**THE FOLLOWING CHANGES ARE PRESENTED HERE FOR
DRAWINGS**

THESE DRAWINGS ACCOMPANY AND ARE PART OF THE PERMIT APPLICATION DOCUMENTS TITLED, "WESTMORELAND WASTE, LLC SANITARY LANDFILL, NORTH AND SOUTH EXPANSION PHASE II MAJOR PERMIT MODIFICATION", DATED DECEMBER 2001, REVISED NOVEMBER 2002 BY G.N. RICHARDSON AND ASSOCIATES, INC. AND RZI ENVIRONMENTAL MANAGEMENT CONSULTANTS.

**WESTMORELAND
SANITARY
LANDFILL**

46A

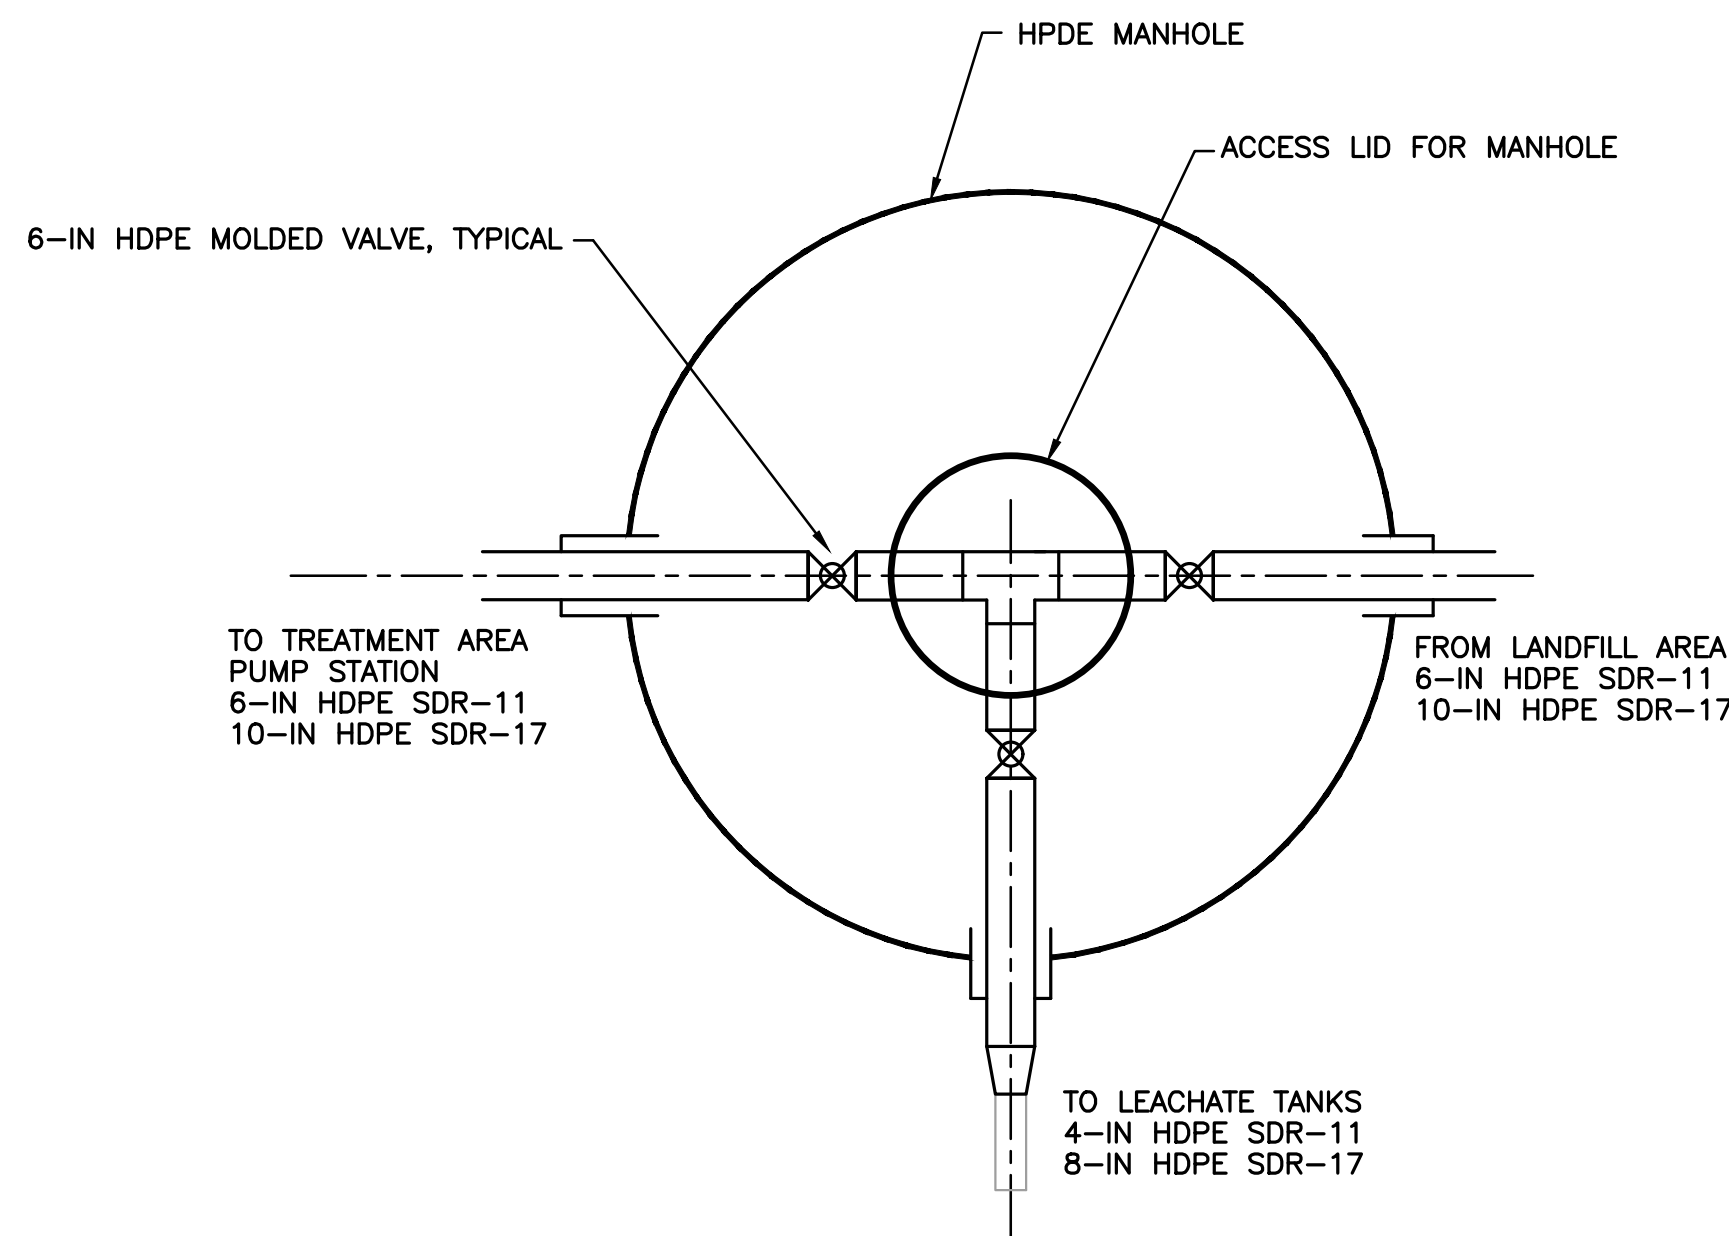
| ① | 10/30/25 | REVISED GRADING FOR TREATMENT PLANT. | KAF | DWM |
